# Access Compliance Report

## Public Rights-of-Way

### (Curb Ramps)

Intersection ID: 12695	Main Street: S_CALDWELL_ST	Cross Street: E_TRADE_ST	Location:	N
ADA ID: 12A0F0987F45	Ramp Type: Perp	Initial Pass/Fail: Pass	Overall Compliance: No	Severity Score: 2.5

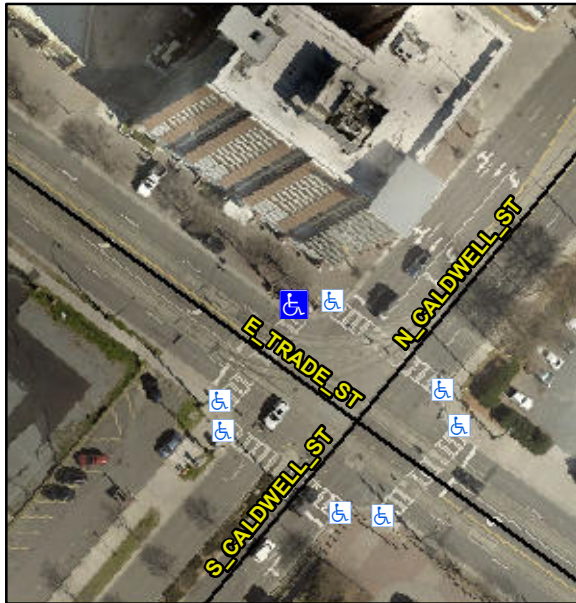
**Not Found, R304.5.3, R305.1.4**

Compliance	Description	Data	Compliance	Description	Data
N/A	Ramp Length (in)	66.0	Yes	Ramp Slope (%)	6.8
Yes	Ramp Width (in)	48.0	Yes	Ramp XSlope (%)	1.8
N/A	Flare Type LT	Sloped	N/A	Flare Type RT	N/A
N/A	Flare Slope LT (%)	8.3	N/A	Flare Slope RT (%)	5.9
N/A	Flare Traversable LT?	Yes	N/A	Flare Traversable RT?	No
Yes	Landing Length (in)	48.0	Yes	DWS Provided?	Yes
Yes	Landing Width (in)	48.0	Yes	DWS Contrast?	Yes
Yes	Landing Slope (%)	1.8	Yes	DWS Length (in)	24.5
No	Landing X Slope (%)	2.5	No	DWS Full Width?	No
N/A	Landing Curb? (Y/N)	No	Yes	DWS Offset (in)	1.5
N/A	Shared Landing?	No			
Yes	Gutter Ponding?	No	Yes	Gutter Slope (%)	2.1
Yes	Gutter Lip Ht (in)	0.0	No	Gutter X Slope (%)	2.2
N/A	Painted X Walk1?	Yes	N/A	Painted X Walk2?	N/A
	X Walk 1 Direction	To SW		X Walk 2 Direction	N/A
N/A	X Walk 1 Width (in)	110.0	N/A	X Walk 2 Width (in)	N/A
	X Walk 1 Slope (%)	2.3		X Walk 2 Slope (%)	N/A
	X Walk 1 X Slope (%)	1.1		X Walk 2 X Slope (%)	N/A

**Remove & Replace Entire Ramp.  
Remove & Replace Gutter.**
